CITY PLAN COMMISSION STAFF REPORT

March 19, 2025

Project Name
Lewer Plaza Apartments

Request
CD-CPC-2025-00013
Development Plan

Sheet Title
LANDSCAPE PLAN CONCEPT

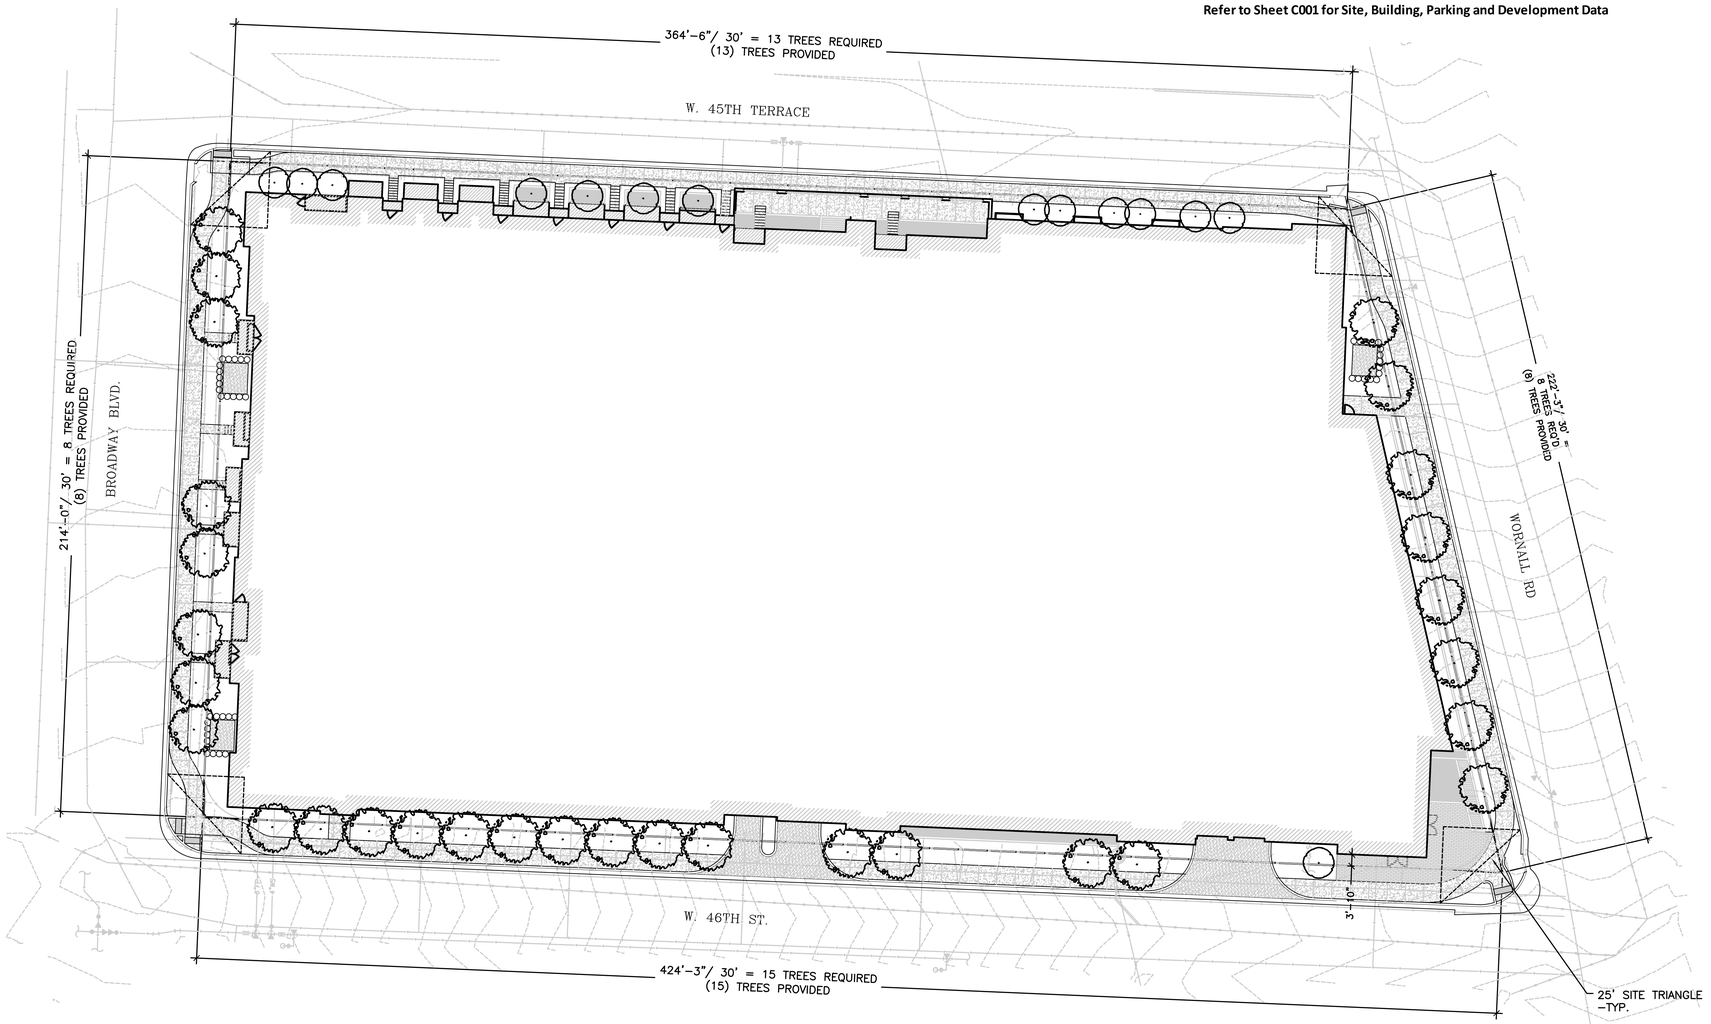
The applicant is proposing appropriate quantities of landscaping for the development; however, staff has added a condition that the applicant revise the plans to include more native varieties prior to ordinance request to ensure the landscaping can thrive in the Kansas City, MO climate and city environment. Staff is pleased to see that landscaping is being used to provide relief from the blank walls that were created by the parking garage. As of the publication of this report the proposed trees include Columnar Hornbeam, Crimson Spire Oak, Columnar English Oak, and Musashino Japanese Zelkova.

8. The applicant shall add bike racks for short term bicycle parking outside of the parking garage prior to ordinance request.
9. The applicant shall revise the landscape plan to include more native varieties prior to ordinance request.

SITE PLAN-PHOTOMETRIC
SCALE: 1" = 20'-0"

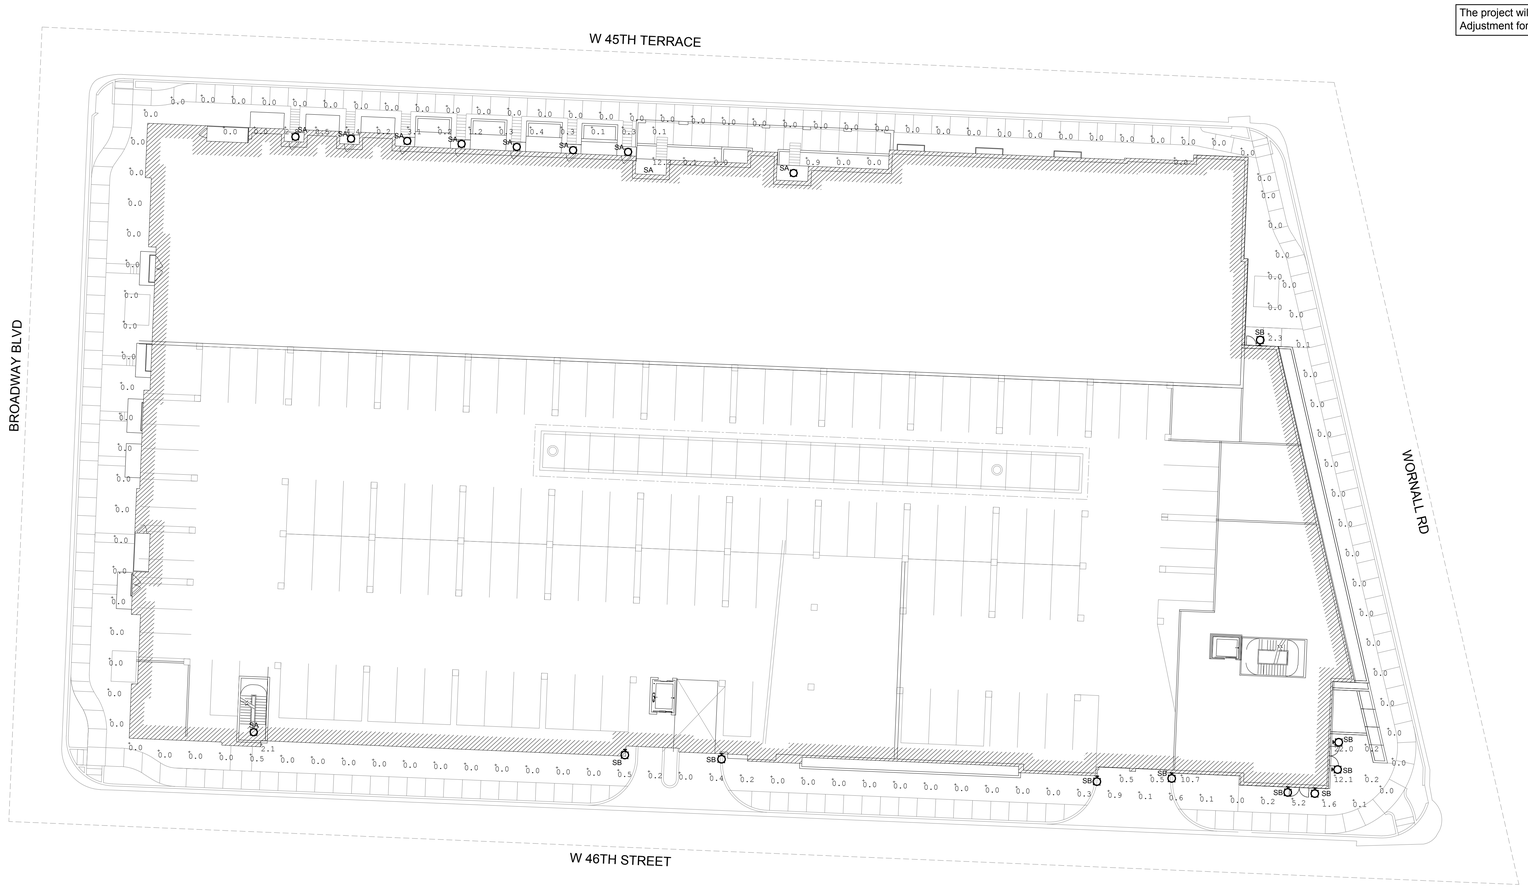
- Lighting should be minimized on the upper levels to avoid intrusion into surrounding neighborhood properties and windows. It would be helpful if the lighting engineer would show on the lighting plan the lighting levels on the upper floors.

- The Developer has stated that it intends to use full cutoff fixtures, which should be shown on the development plan, and be a condition, to be a binding commitment, and not just an oral statement.

- The City requires significantly lower lighting levels adjacent to residential zoned properties, and the properties on the east, north and west are all residentially zoned properties. That should be known by the Developer and enforced by the City. That limitation should be a condition to the development plan.

The project will seek an exception for Ordinance 88-430-05-C through the Board of Zoning Adjustment for locations in which the light spill at the property line exceeds 1.0 fc.

Sheet Title
ELEVATIONS

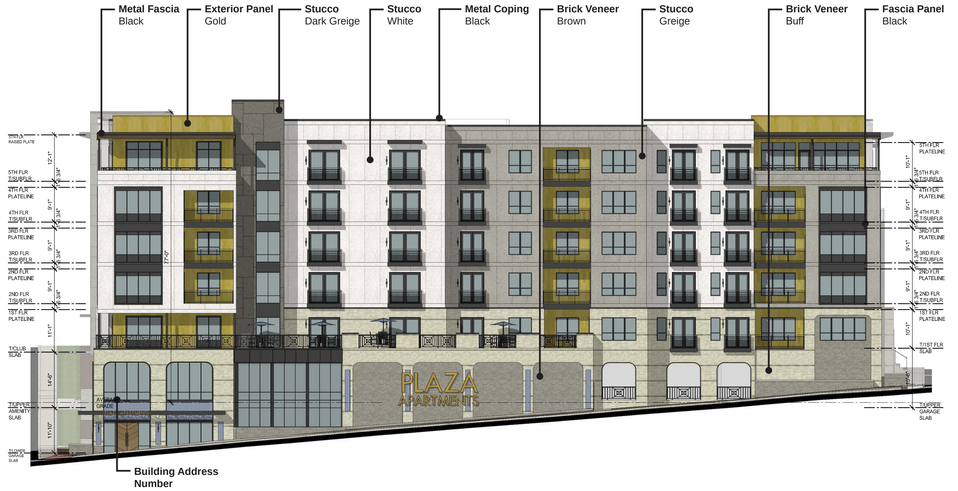
The development plan shows an average height of 77 feet, without any step down in grade as the site slopes down to the southeast. The MPAP recommends a maximum height of sixty-five feet (see MPAP page 45). The Long Range Planning Division requested a reduction of building height. See Comment 12 of the Development Review Committee Comment Letter dated February 14, 2025 (DRC Comment Letter). HKC has advocated for adherence to the MPAP to provide guidelines that can be relied upon by property owners in their investments. **HKC supports the request made by the Long Range Planning Division for the building not exceed a maximum height of sixty-five feet and encourages the City Plan Commission to condition its recommendation of the development plan to reduce the maximum height to sixty-five feet, or to continue this case until a further revised development is presented that modifies the maximum height**.

- As observed by Long Range Planning staff in comment number 12 of the Development Review Committee comment letter dated February 14, 2025 (DRC Comment Letter), a reduction to a maximum height of 65 feet would bring the proposed project into compliance with the recommendations of the MPAP.
- The reduction in height could also have the benefit of reducing the number of units, lessening the need for the requested deviation of lot area per unit.
- The excessive height is most pronounced as the grade drops to the southeast. Reduction in height in that portion of the proposed project could better implement the Plaza Bowl Concept in the MPAP.
- Within the Plaza Bowl Concept the means of measuring building height is shown on Page 49 of the MPAP and suggests a stepdown of the height as the grade steps down.
- A stepdown as the grade steps down is preferred by PWNA.
